URBAN DESIGN CONSULTATION RESPONSE

Design Officer	Azhar Kapadi
Date	29.04.25
Application Reference	25/00149/VRCON
Address	Longley Hey Farm, Halifax Road, Littleborough, OL15 0LB
Proposal	Application for minor material amendment to approved planning application 23/01280/FUL for the erection of replacement dwelling

East Elevation

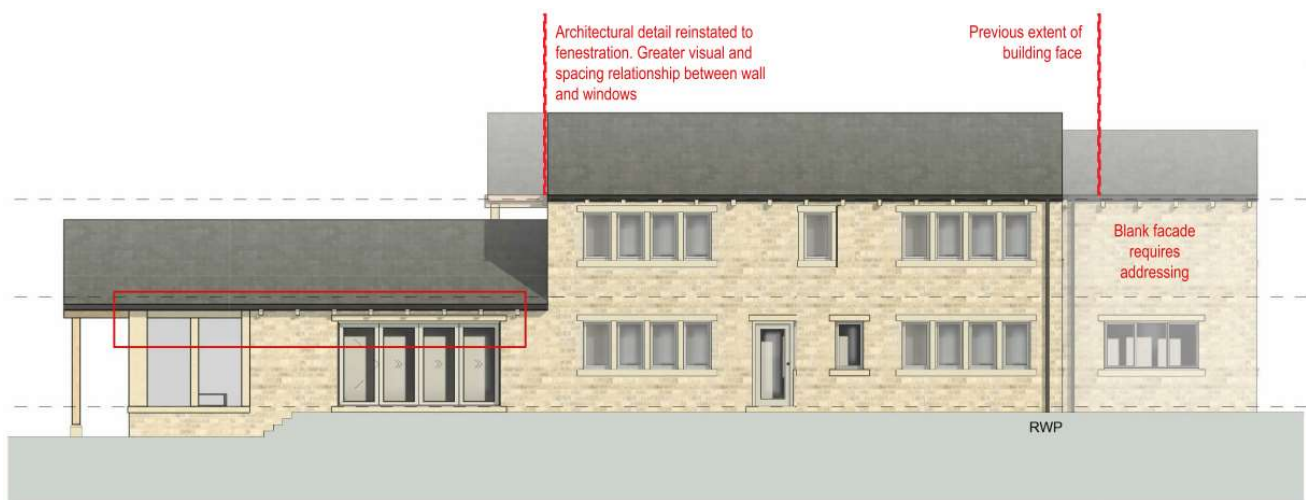
Proportionally, the building does not read well as it previously did. Applicable for both east / west elevations in particular, the different facade components do not relate well with each other. This is most likely because there are large swatches of blank walls, making the elevation appear quite flat. *Could windows increase in width? Does the overall footprint need to reduce slightly for the massing to work more successfully?* This is something the architect must address.

The previous design proposals showed interesting stone mullion bars between window panes – this is something that is characteristic of the positive architectural examples in the area. The absence of this in the elevations has contributed to the reduced design quality of the proposal.

East Elevation

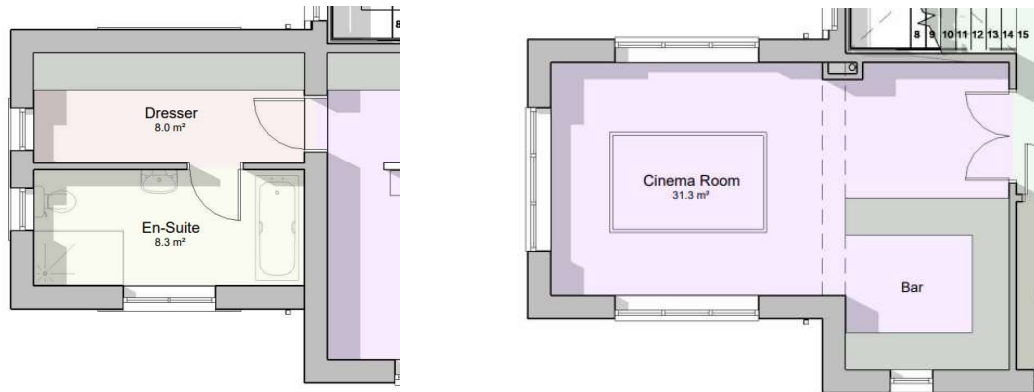
In the kitchen location, extend the glazing so it matches the glazing that wraps around the corner; the single storey element will be read as one entity and it would be more logical if these proportions matched each other.

To the right hand corner, the elevation is blank at first floor level dictated by the plan. This looks rather awkward visually and a recess outline of stonework where a window and surround could have been MAY help reducing this elevation from being too empty and monotonous, otherwise an internal reconfiguration may be necessary.
